This Service Letter reidentified a Service Bulletin M 30-110 per Service Instruction M20-15.

SUBJECT:

Rerouting of Oil Lines to the Oil Cooler

M20C, Serials 1852, 1940-2475 M20D, Serials 1, 101-170

FIGURE 1

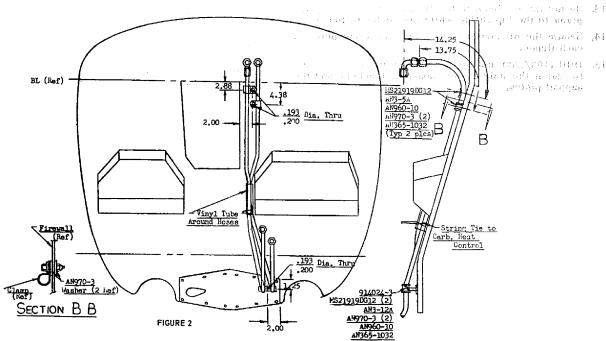
- Install the two 90° fittings in the oil cooler as per Figure 1.
- 10. Remove the air deflector from the oil cooler.
- 11. Install and route both oil lines per Figures 1, 2, and 3.

- 12. Slide the oil cooler into position with the fittings toward the center line of the engine.
- 13. Secure the oil lines to the fittings with the long line going to the top fitting while the cooler is loose.

- 16. Install the two remaining bolts.
- 17. Re-install the air deflector with the two long bushings to the outboard side.
- 18. Clamp the lines as per Figures 2 and 3.
- 19. Patch the holes in the cowling baffles with .032 2024-T3 clad aluminum patches.
- 20. Re-install the top left baffle.
- 21. Install the cowlings.
